MONTGOMERY COUNTY HISTORIC PRESERVATION COMMISSION
STAFF REPORT

Address:	7409 Baltimore Avenue, Takoma Park	Meeting Date:	12/16/2020
Resource:	Contributing Resource Takoma Park Historic District	Report Date:	12/9/2020
Applicant:	Stacey Katz & Robert Fegley (Paul Treseder, Architect)	Public Notice:	12/2/2020
Review:	HAWP	Tax Credit:	N/A
Case Number:	37/03-20YYYY	Staff:	Michael Kyne
PROPOSAL:	Partial demolition and new rear addition

Fig. 1: Subject property.

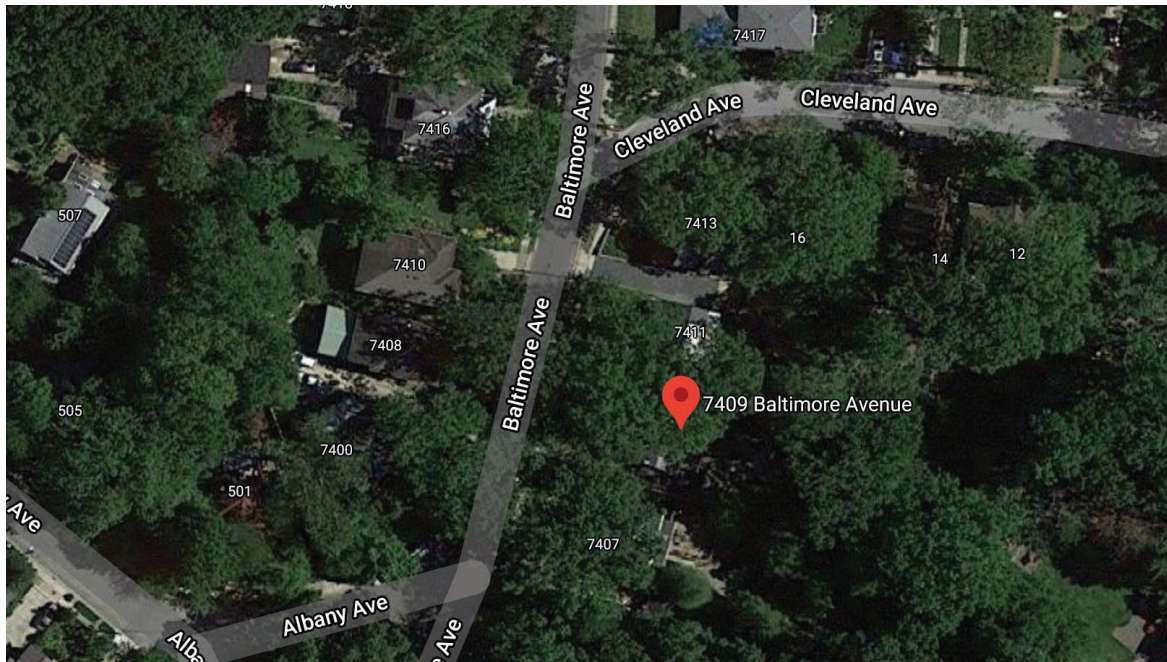
The subject property is a c. 1910-20s 1 ½-story Bungalow-style house within the Takoma Park Historic District. There is an existing 1-story rear addition with aluminum siding and vinyl-clad wood windows, which likely dates to the 1980s. The 1927 Sanborn Fire Insurance Map depicts a 1-story open (at least partly) porch in the approximate location of this addition, suggesting that it may actually be an enclosed historic porch.

REAR ELEVATION - EXISTING

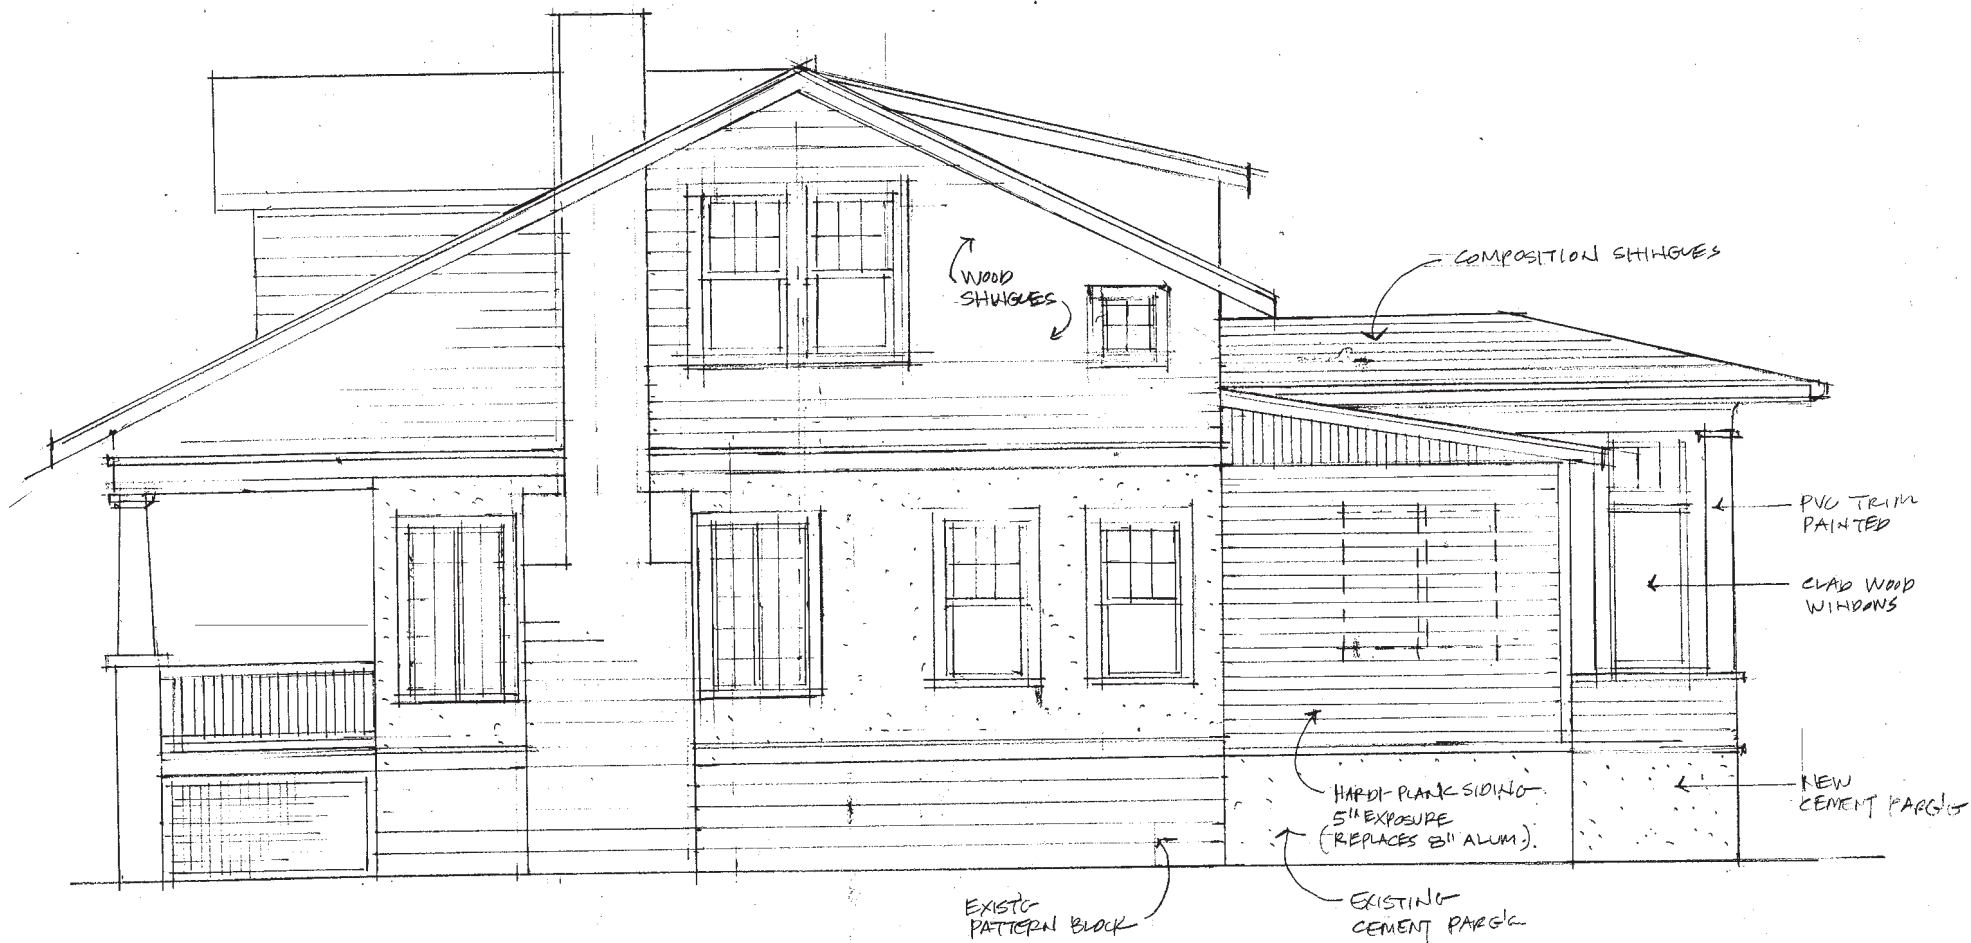
The applicants propose to remove the aluminum siding from the existing addition/rear porch enclosure and install new 5" exposure fiber cement clapboard siding in its place. The existing vinyl-clad wood windows will remain in place. Because documentary evidence suggests that the existing addition may actually be an enclosed historic porch, staff recommends the following condition of approval:

Staff discussed the proposal with the applicants' architect, who concurred that there may be existing/historic siding beneath the aluminum siding. The architect indicated that the applicants would be amenable to the condition.

1. Staff will be consulted in the field on the viability of preserving any existing/historic siding that may be present, once the aluminum siding is removed from the existing addition/rear porch enclosure. If there is any existing/historic siding present, it will be preserved. If the siding is severely deteriorated, it will be replaced in-kind with wood of matching dimensions. The specifications of any required replacement siding will be reviewed and approved by staff.

REAR ELEVATION, PROPOSED ADDITION.

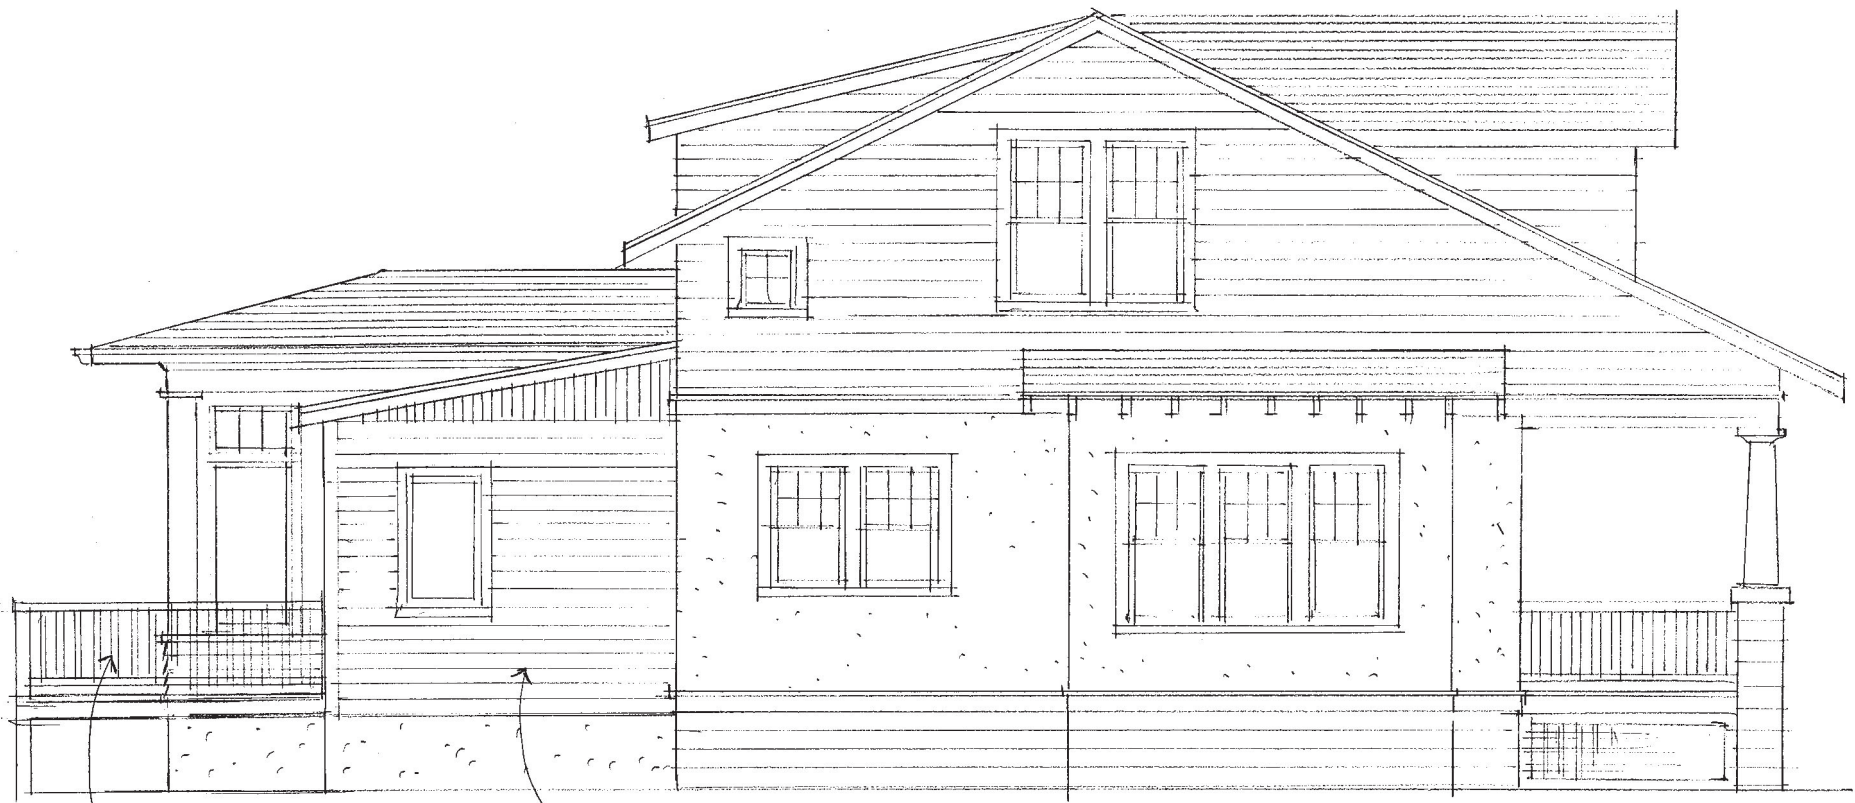
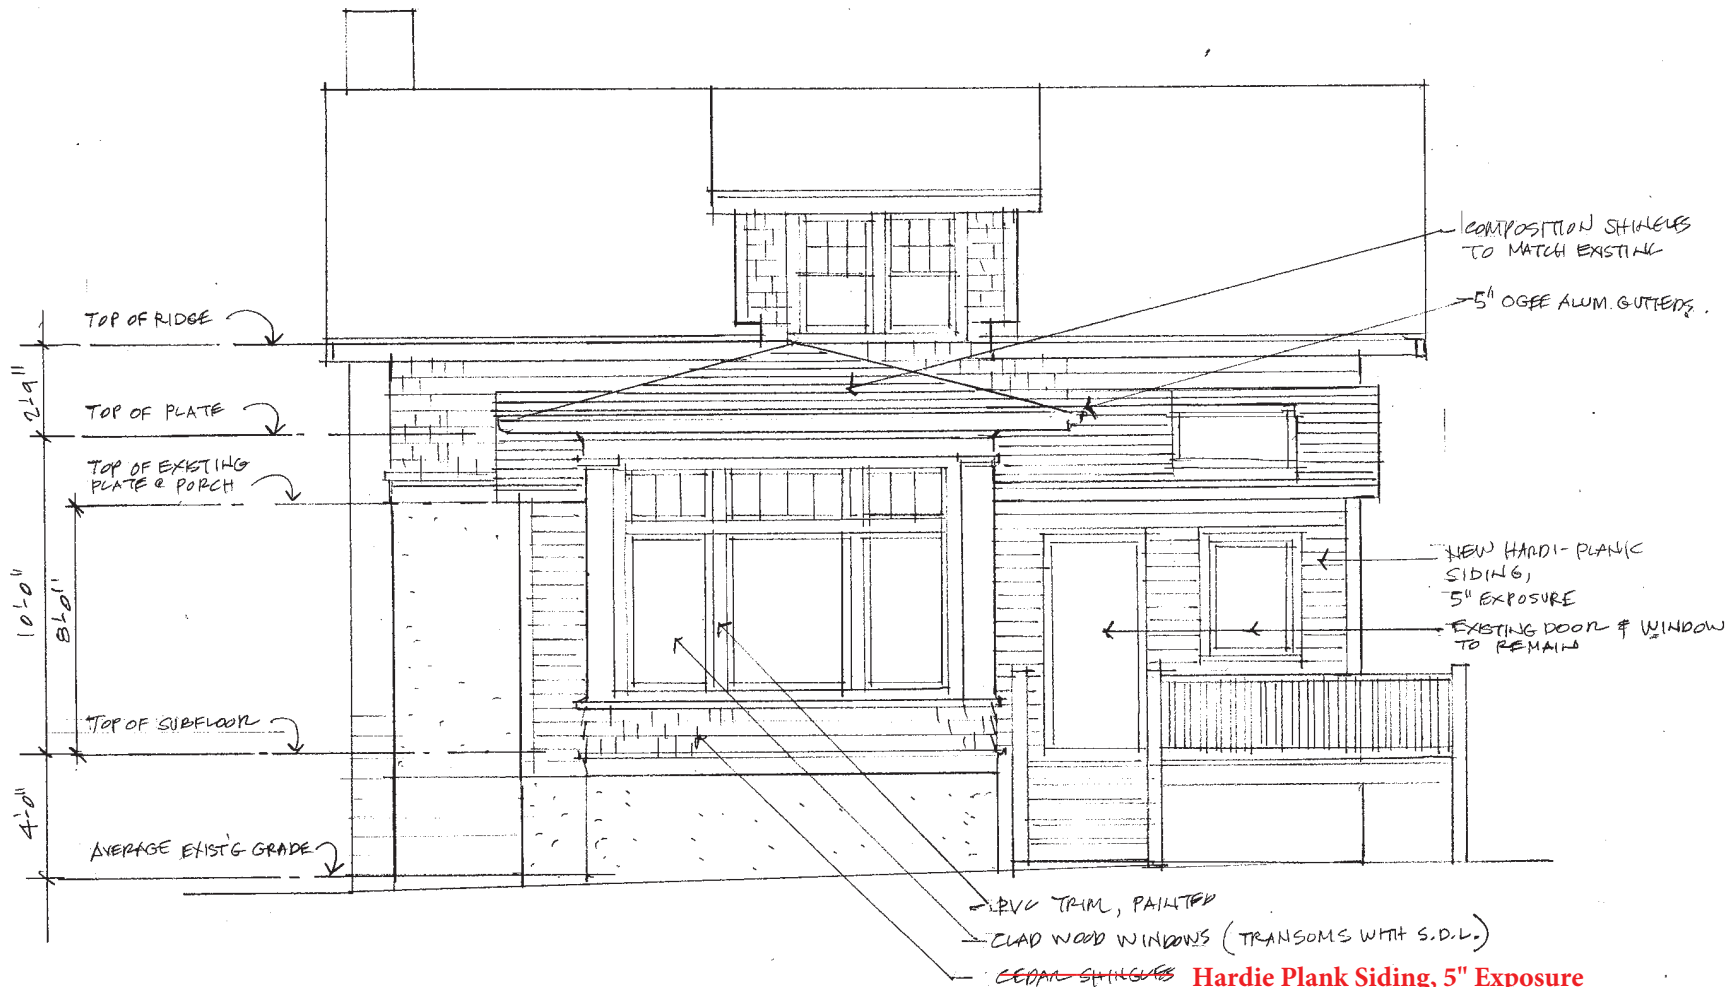
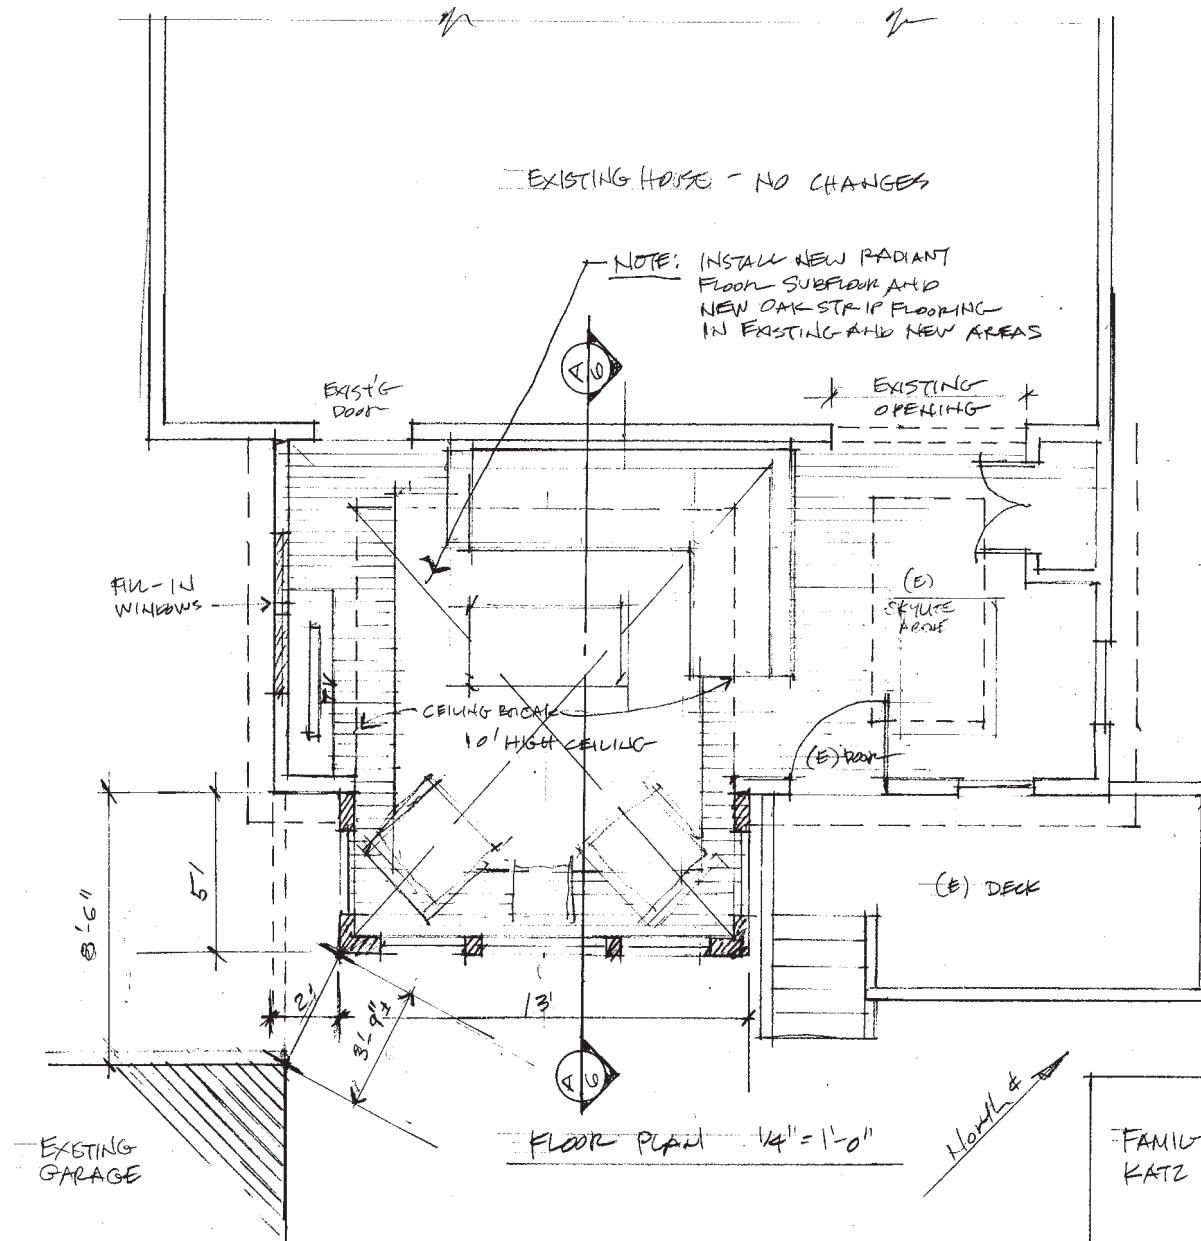
A new 5' deep and 13' wide 1-story addition is also proposed at the rear of the existing addition/enclosed porch. The ridgeline of the proposed new 1-story addition will be well below the ridgeline of the 1 ½-story historic house, and it will be well inset from the rear corners of the existing addition/enclosed porch and historic house, making it negligibly visible from the public right-of-way of Baltimore Avenue, at best.

- Painted PVC trim
- 5" exposure fiber cement clapboard siding
- Single-lite aluminum-clad wood casement/awning windows
- Simulated divided lite aluminum-clad transom windows
- Composition shingle roofing to match the existing
- Parged cement foundation
